Report to Norwich highways agency committee

Subject Transport for Norwich – Cycling improvements
St Clements Hill

To consider the responses to St Clements Hill junction improvements and 20mph area statutory consultation and approve the amended proposals for installation.

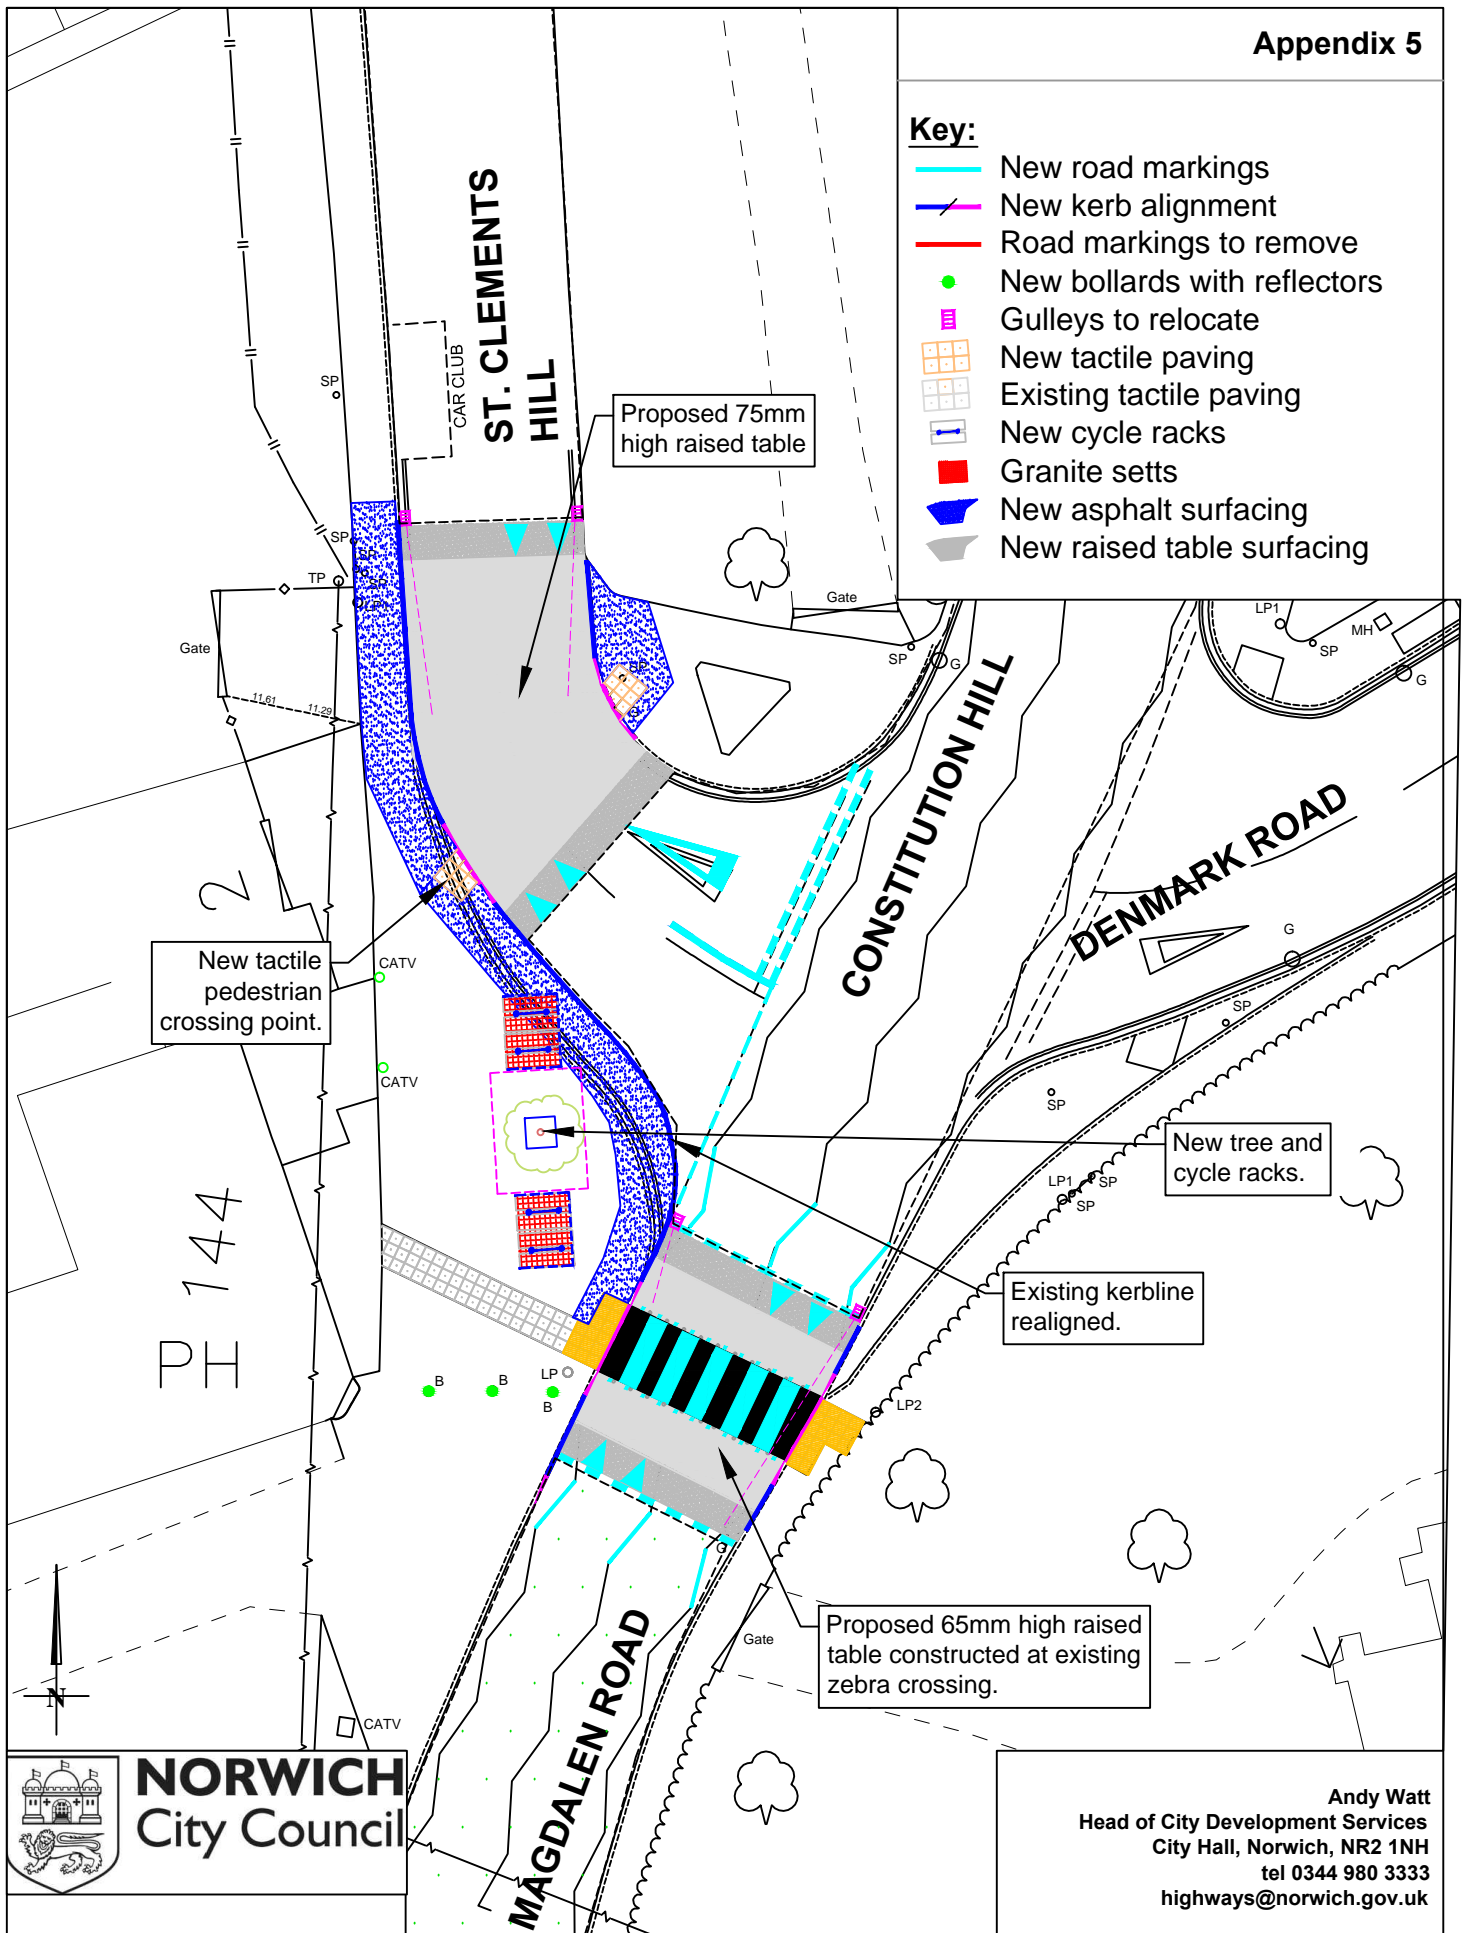
18. Nine respondents stated that they felt the north bound cycle lane at the above junction was not needed. Some said they felt it was safer and easier for cyclists to stay on the road and take the left turn, but help was needed turning right out of St Clements Hill at this junction, which the proposals do not address. Nine respondents advised the cycle lane would cause conflict between cyclists and pedestrians. Five respondents stated that the proposed cycle stands were not needed and five were concerned with the positioning of the existing car club bay on St Clements Hill. Deliveries to the local public house were also a concern.

19. The Norfolk and Norwich Association for the Blind (NNAB) and the Guide dogs Association stressed that the cyclepath, which would cut through the tactile paving for the zebra, would be unsafe for Visibly Impaired People (VIPs), causing conflict between pedestrians and cyclists. They suggested as the cycle lane would probably be used by cyclists travelling in both directions at speed, this would only increase the danger. The 25mm upstand on the edge of the cyclepath was considered appropriate.

21. The Whalebone Public House Agree with the introduction of the 20mph zone extension and with minimum parking restrictions around junctions to allow parking for residents. They believe the proposed cycle lane outside their PH would cause conflict between cyclists and pedestrians and customers. They were concerned with deliveries that need direct access to the cellar trap door and advised there were no

No. of responses from residents	Comments received	Officer comments
5	There will be a conflict between cyclists and pedestrians / pedestrian crossing.	This is a possibility and the design has been chosen to minimise this.
3	The cycle lane at Magdalen Road junction will encourage cyclists to stay on footpath.	There will always be some who chose to cycle on the pavement. There will be adequate signs and road markings to indicate to the rider that they should re-join the carriageway.
1	Agrees it is difficult for pedestrians to cross St Clements Hill at its junction with Magdalen Road.	For this reason the raised table will slow traffic and the enhanced crossing point will help pedestrians negotiate crossing the road.
2	Concerned with the recent introduction of the car club bay on St Clements Hill as it is close to the junction with Magdalen Road.	The recently positioned car club space was installed after consultation. It is considered a suitable position in this 20mph area, but will be reviewed if a nearby development is proposed.

1	Realigning the kerb at the Magdalen Road junction will increase traffic congestion and fumes. Suggests realignment of Denmark Road junction.	The realigning of the kerb at Magdalen Road is necessary to incorporate the raised table for the zebra crossing. It will also slow traffic further turning into St Clements Hill. Denmark Road junction is considered suitable.
1	The raised table at the zebra on Magdalen Road near the junction with St Clements Hill will make hand signals dangerous for cyclists, especially when wet.	It is important for cyclist to control their bikes when riding over a raised table, but a hand signal could be given prior to the table.
1	Extra signage will add to street clutter.	The proposal of making the southern section of St Clements Hill into a 20mph zone (rather than a limit as existing) will reduce the number of signs necessary in the area.
<u>Other comments</u>		
1	Traffic calming is needed on Woodcock Road (between Catton Grove Road and Wall Road)	Woodcock Road is outside this scheme.

28. Many concerns of the usefulness of the cycle lane at the Magdalen Road junction have been voiced with doubts over the benefit it will give to cyclists and the possibility of conflicts with pedestrians. Alternative solutions to concerns at this junction such as a mini roundabout or a signalised junction have been suggested, but these are not appropriate due to the geography of the junction, budget limitations and suitability for this 20mph environment. The position of the existing car club space on St Clements Hill is considered suitable on this 20mph road which will be further enhanced by the proposed raised table at the junction. In consideration of the responses received it is proposed to not install the cycle lane at this junction.

4	It is very difficult for cyclists to turn right (south) from St Clements Hill into Magdalen Road.	The proposed raised table at the Zebra crossing will help slow traffic down and make manoeuvres easier for all road users.
3	The cycle path is not necessary	The cycle path would give an easier route for cyclists travelling north.
1	The cycle stands will not be used and are unnecessary.	It is important to enhance the environment and improve cycling facilities where possible to encourage cycling. It is also important to plan for the future and likely increase in cyclists.
2	The proposed tree is not necessary and will cause visibility problems at the junction.	As above, it is important to enhance the environment. The tree position will not to obstruct road users views at the junction.
